**PERMIT**  
**INDEXED**  
**SANDMOUND SYSTEM**  
**ON-SITE SEWAGE DISPOSAL SYSTEM**  
**HOWARD COUNTY HEALTH DEPARTMENT**  
**BUREAU OF ENVIRONMENTAL HEALTH**  
TAX ID# 05-353580

ADDRESS: 14101 Howard Road PROPERTY OWNER: Mark & Anna Smith

## SAND MOUND DESIGN

**SITE DEVELOPMENT,  
SEDIMENT/EROSION CONTROL PLAN, NOTES & DETAILS**  
**HOWARD ROAD  
PARCEL 100**  
ZONED: RC-DEO LIBER 612 FOLIO 232  
TAX MAP NO. 27 PARCEL NO. 100 GRID NO. 1B  
5TH ELECTION DISTRICT HOWARD COUNTY, MARYLAND  
SCALE: 1"=50' DATE: MARCH, 2005

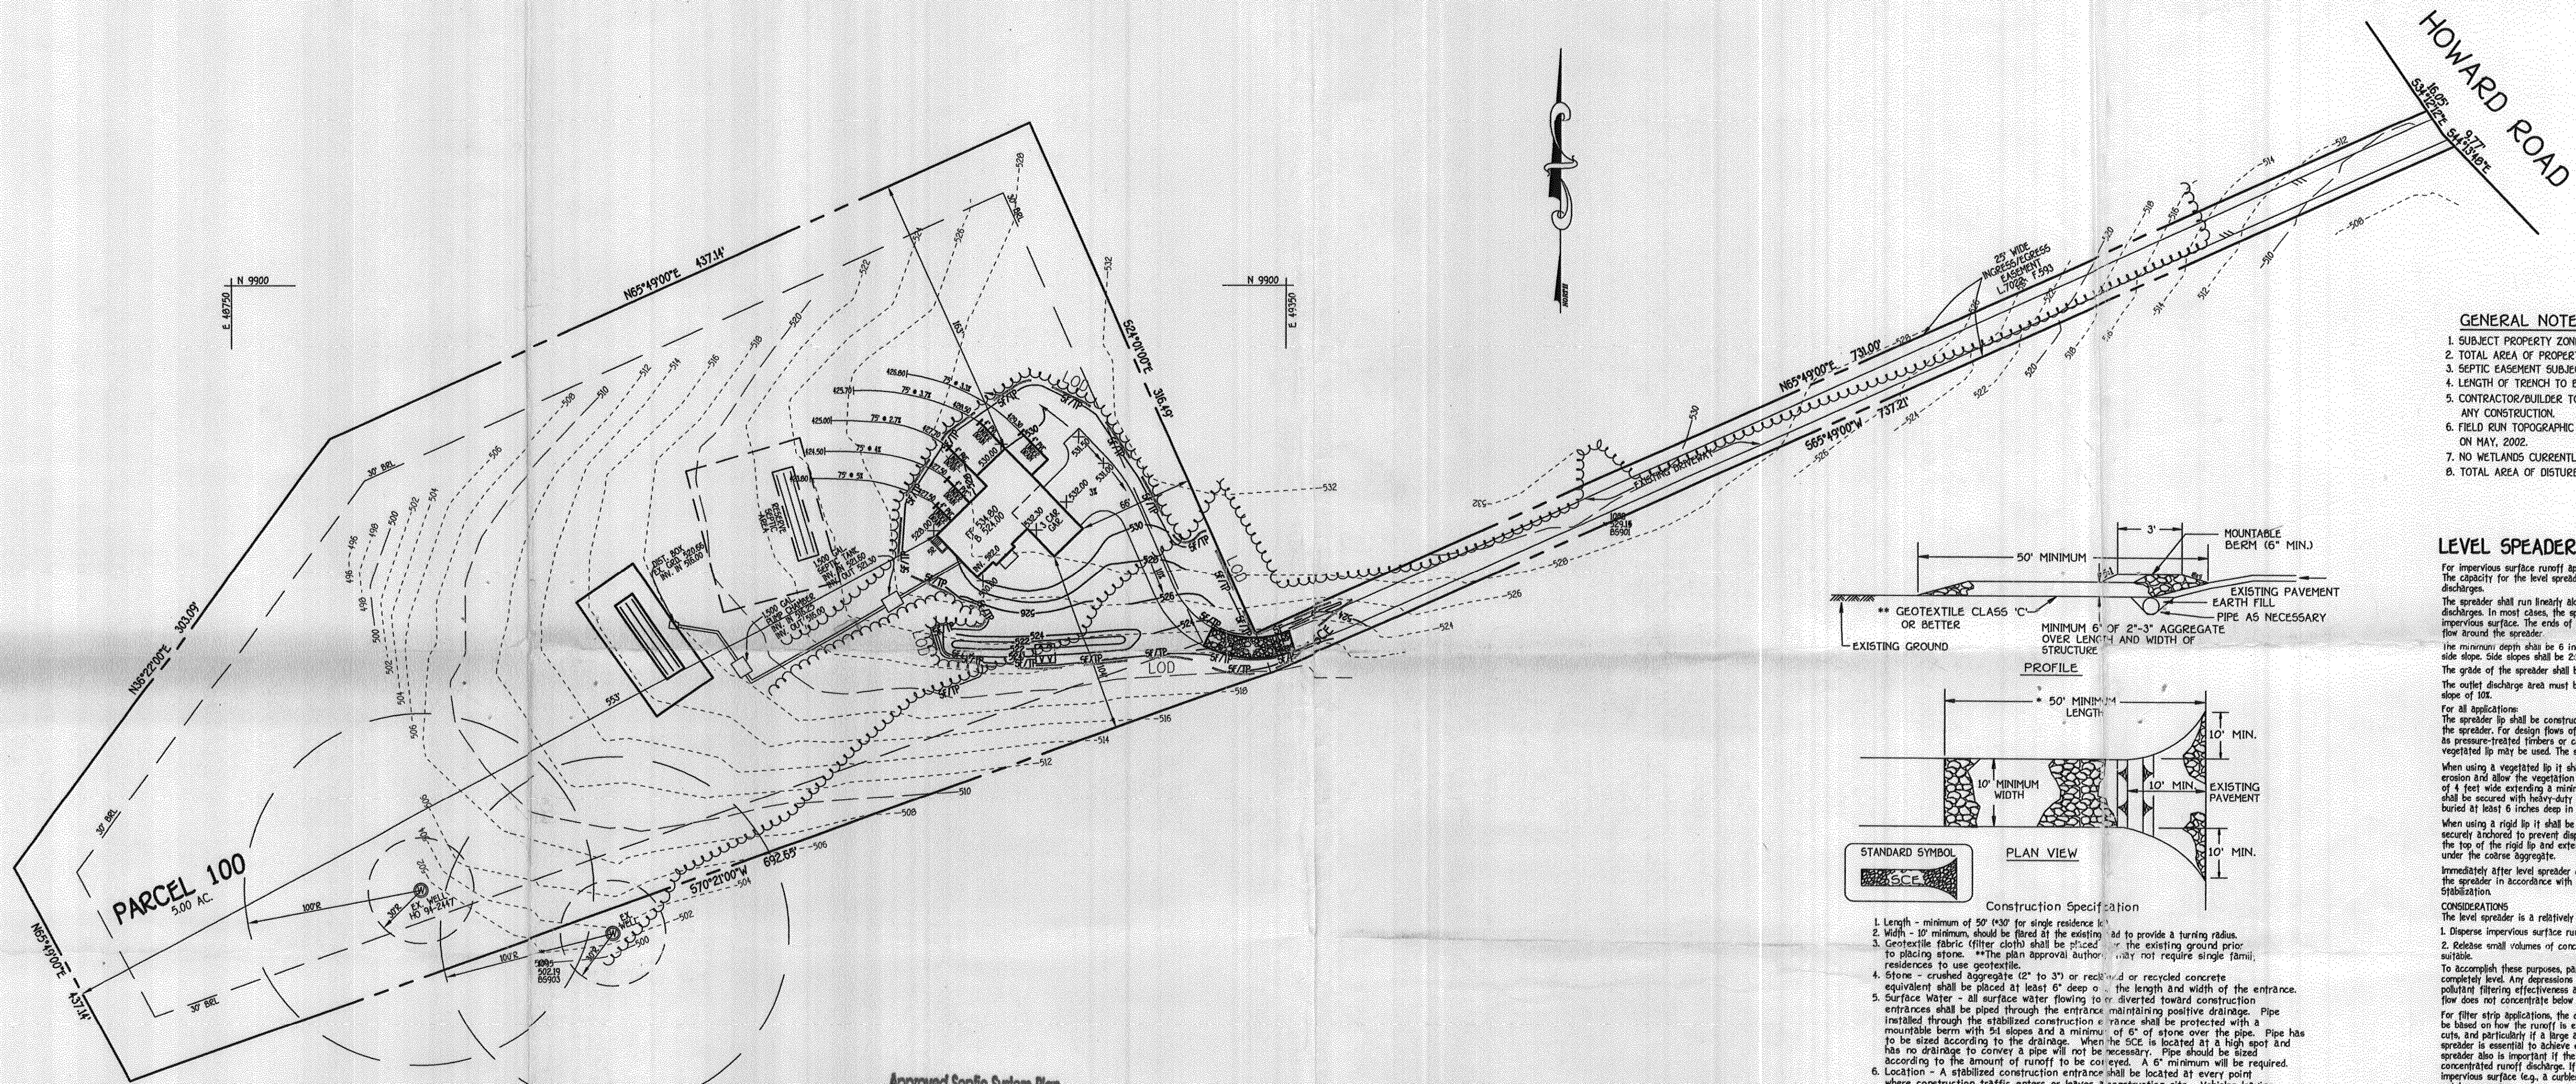
*The assumed 5% slope  
 I have to use 6% slope  
 (Holes in cover only)*

$\frac{30.48}{24} = 1.27$   
 $\approx 54.5$

Sideslope setback (K) =  $\frac{29.25 + 24 = 53.25}{2} \times 3 = 159.75 \text{ in.} = 13.8 \text{ ft}$

Upslope setback (J) =  $(22 \text{ in.} + D) \times 3 \times \text{upslope corr. factor} = 46 \cdot 138 \times 0.86 = 118.68 \text{ in.} = 9.89'$

Downslope setback (I) =  $(22 \text{ in.} + E) \times 3 \times \text{downslope corr. factor} = 52.5 \cdot 157.5 \cdot 1.22 = 192.15 \text{ in.} = 16.01'$

Total Width of Mound (W) =  $12A + J + I = 9' + 9.9' + 16.01' = 34.91'$

*Bed w = 9' + 9.9' + 16.01' @ 0.25 gpd/50ft<sup>2</sup> Soil Load Rate, Basal Area = 3000 sq ft  
 $3000 \div 69.4' = 43.5$  Basal Area width  
 - 9' bed  
 $34.5'$  @ .25 soil load rate*

$9 + 9.9 + 16 = 34.9'$  @ .25 soil loading rate (i.e. 30-60 gpd per rate)
